ATTACHMENT 4 TO AEP:NRC:1071N

EXISTING TECHNICAL SPECIFICATIONS PAGES
MARKED-UP TO REFLECT PROPOSED CHANGES

DONALD C. COOK NUCLEAR PLANT

UNITS 1 AND 2

Figure 5.6-2: Donald C. Cook Nuclear Plant Schematic for Fuel Storage Racks Interface Boundary Between Regions 1 and 2

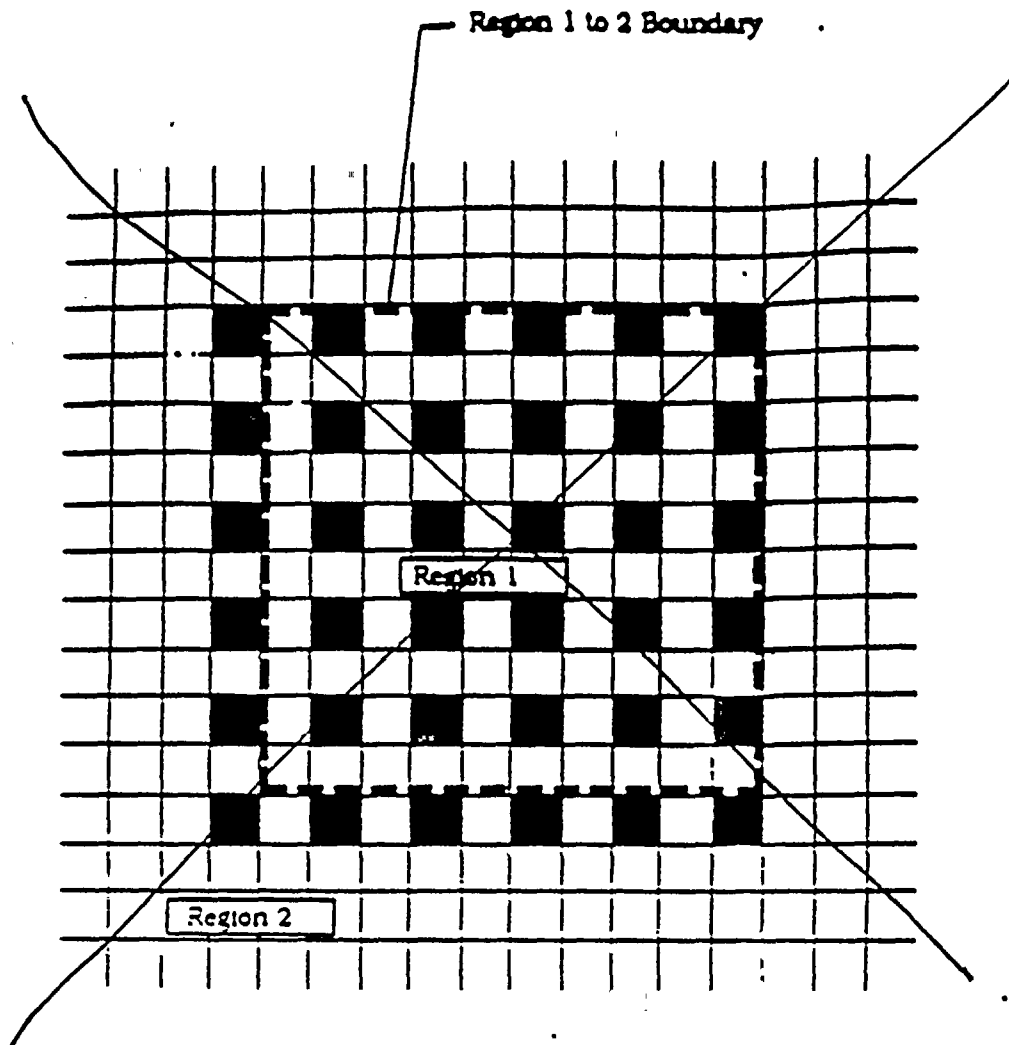
3. The boundary between the Region 1 mentioned above and the rest of the spent fuel storage racks (defined as Region 2) shall be such that the three out of four storage requirement shall be carried into Region 2 by, at least, one row as shown in Figure 5.6-1.

INSERT A: Types of enrichments greater than 3.95 weight percent U-235 and burnup less than 5,550 MWD/MTU in a checkerboard pattern configuration alternating Category 1 and Category 2 fuel as shown

in Figure 5.6-1.

NEW FIGURE

Figure 5.6-1: Donald C. Cook Nuclear Plant Schematic for Fuel Storage Racks Interface Boundary Between Regions 1 and 2

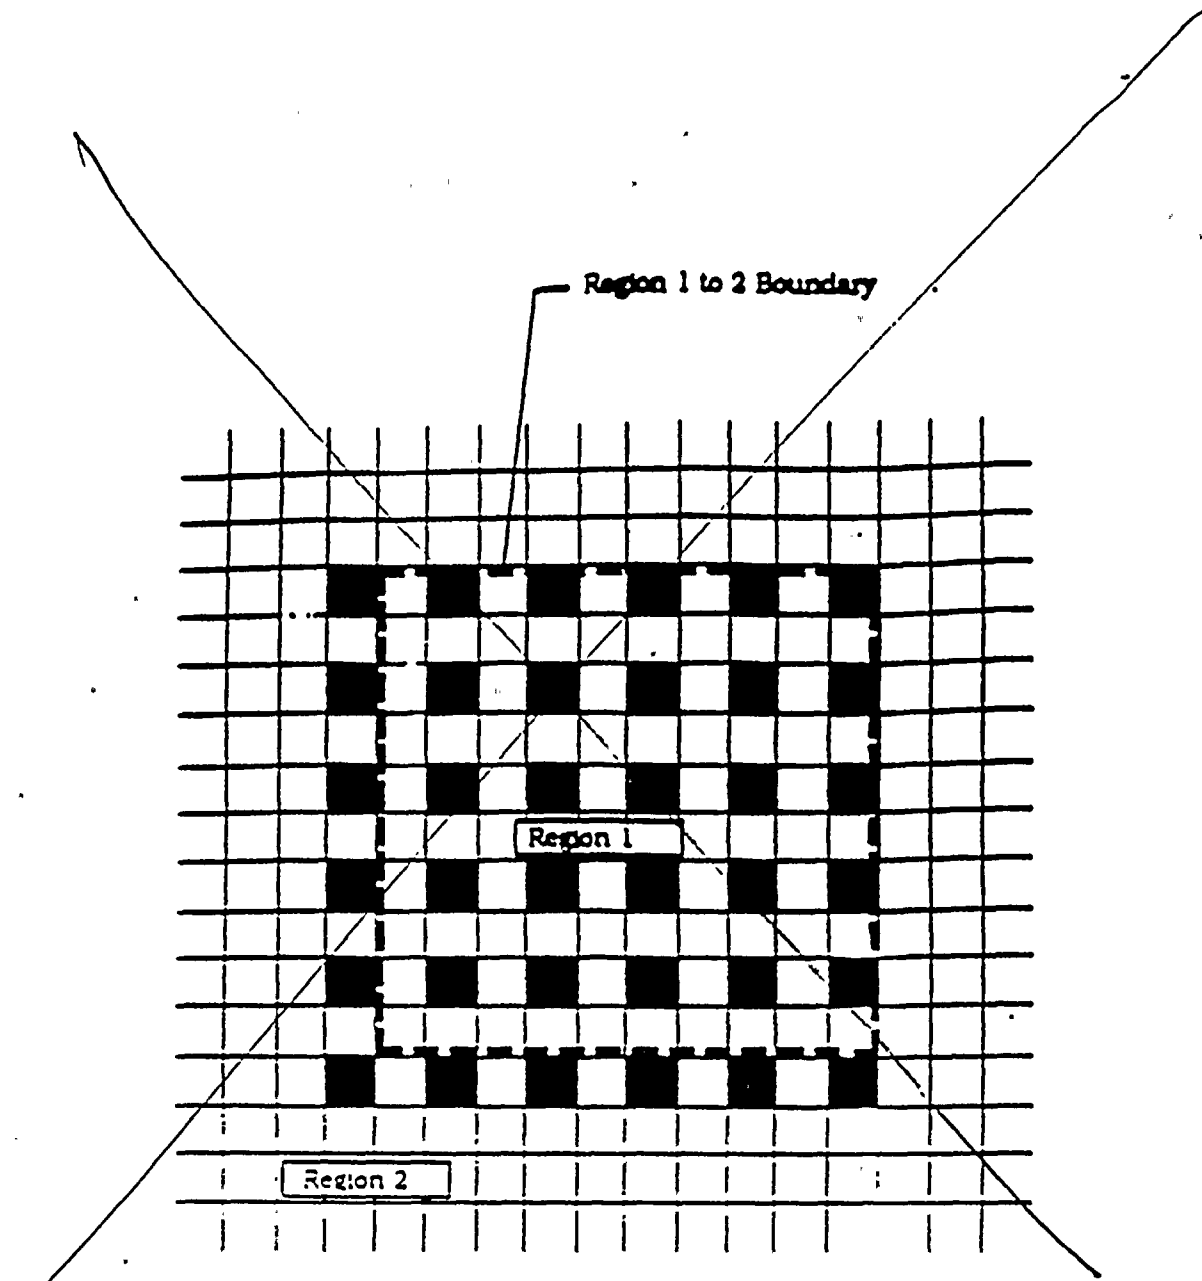
- 2. **INSERT B** and 2
- 3. The boundary between the Regions mentioned above and the rest of the spent fuel storage racks (defined as Region 2) shall be such that the three-out-of-four storage requirement of Region 1 shall be carried into Region 2 by at least, one row as shown in Figure 5.6-1.

INSERT A: types of enrichments greater than 3.95 weight percent U-235 and burnup less than 5,550 MWD/MTU in a checkerboard pattern configuration alternating Category 1 and Category 2 fuel as shown in Figure 5.6-1. Westinghouse Category 1 and Category 2 fuel definitions are given in Figure 5.6-2

NEW FIGURE
